ZTE CORPORATION**Product Change Description**

[Smart Tab 7]
[ZTE Corporation]

is the variant of the initial certified product,

[Smart Tab 7]
[ZTE Corporation]

Front plastic cover change:

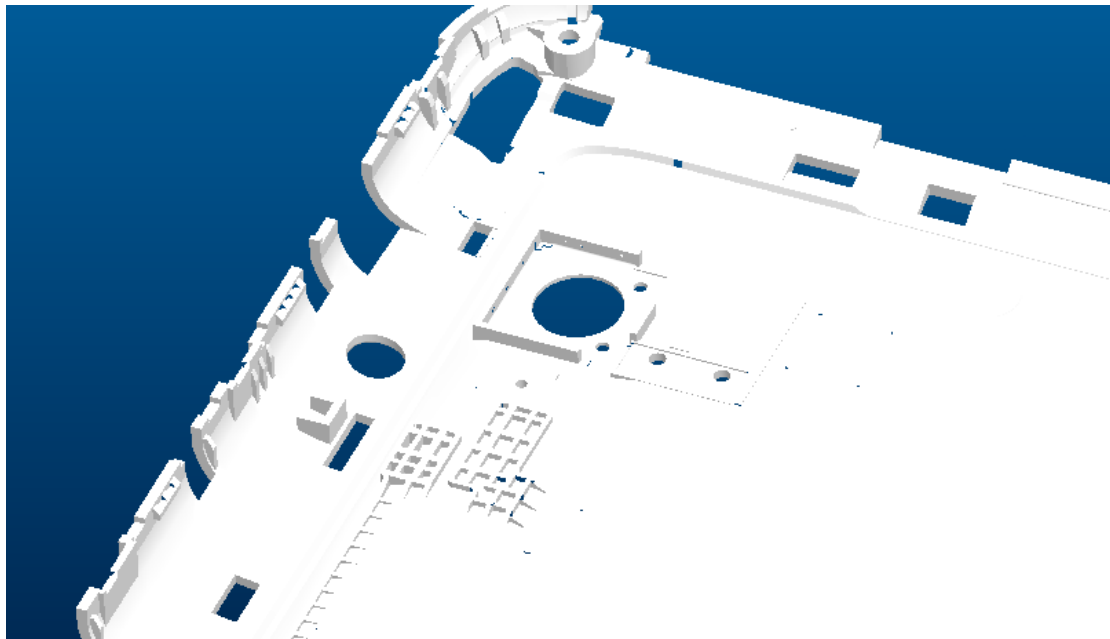
Before:

After:

Reason for changes: enhance strength of front cover.

Back plastic cover change:

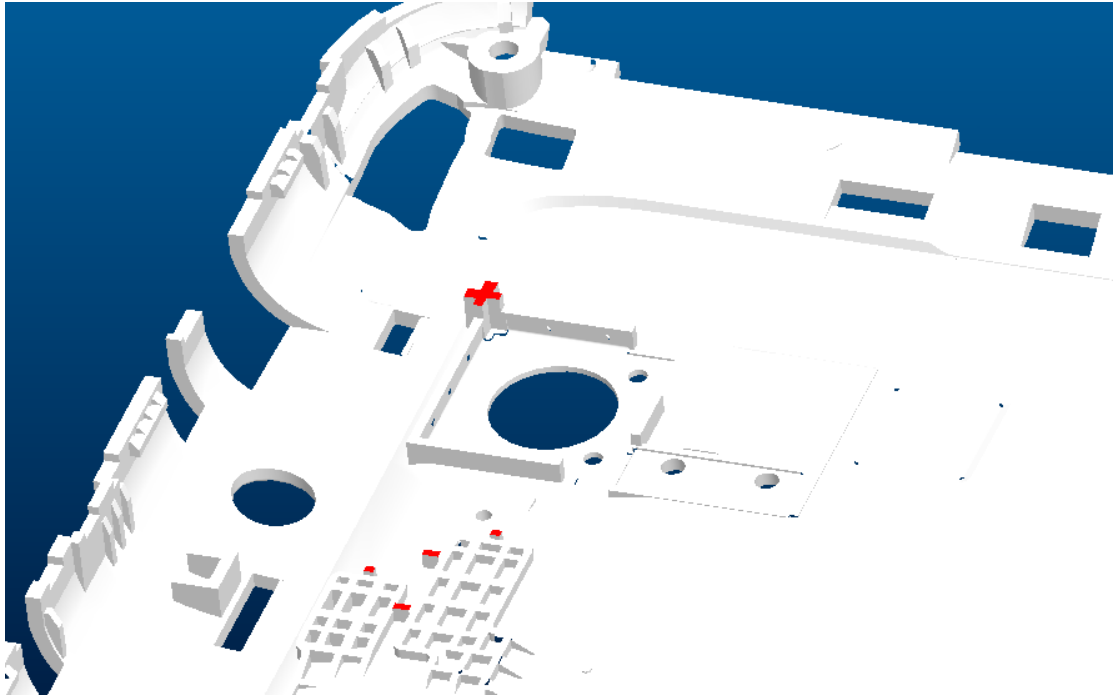
Before:

After:

Reason for changes: First, improve location accuracy of FPC.
Second, support main pcb.
